<b>Subject:</b>  AT - SLIGHT SURGE WHILE DRIVING AT 40-55 MPH	<b>Bulletin No:</b> 05-010/06
	<b>Last Issued:</b> 10/24/2006

1712a

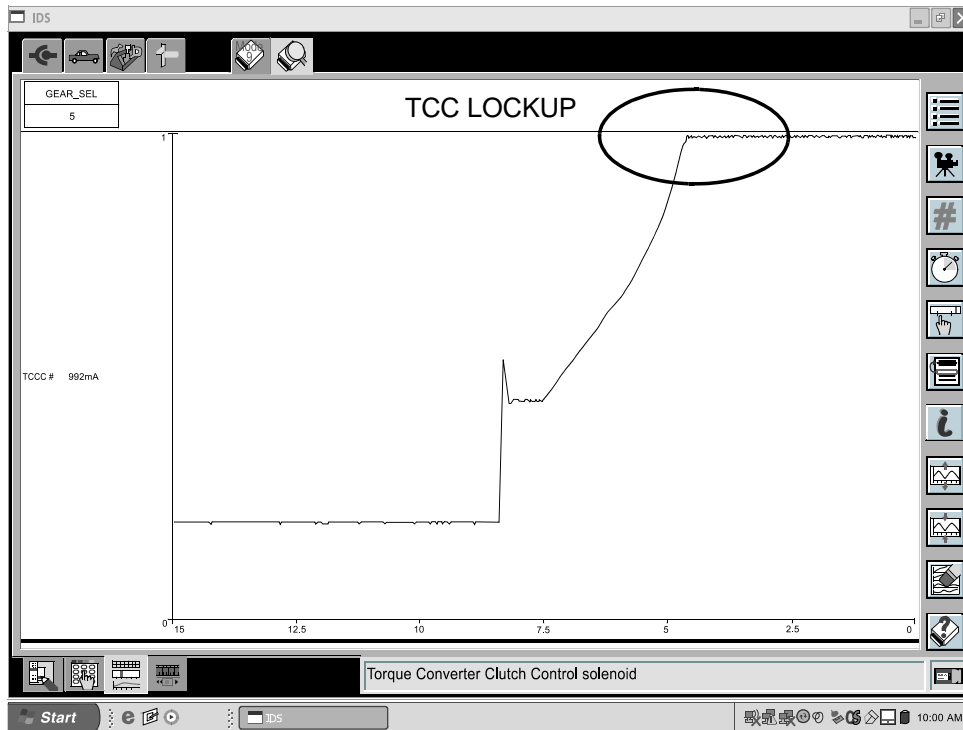
2. Monitor TCCC # and GEAR\_SEL PIDs while driving. If surging occurs while in 5th gear and TCC is locked, proceed to next step. If surging does not occur, return vehicle to customer.

3. Reboot the PDS/IDS to clear memory before reprogramming.
4. Using PDS/IDS 44.6 or later software, reprogram the TCM to the latest calibration (refer to "Calibration Information" table) by following the "Module Reprogramming" procedure.
